DLL Autoclass v100

Info (not part of baseline)

The DLL Autoclass procedure is currently not described in the draft. See [yesebootd_3_0915_v120.pdf](#) for how Autoclass DLL works.

Figure 33–49a — PSE Autoclass control state diagram

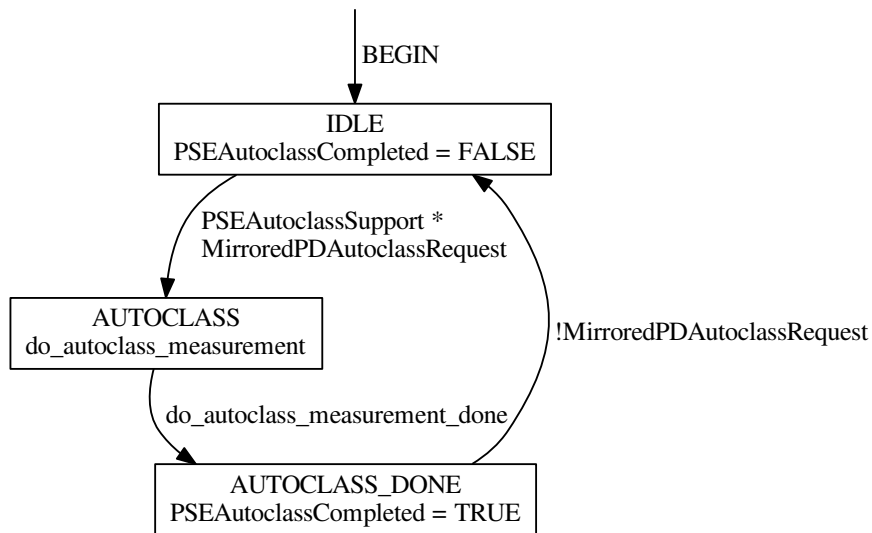
Add the following two figures (redrawn in Frame) after Figure 33–49:
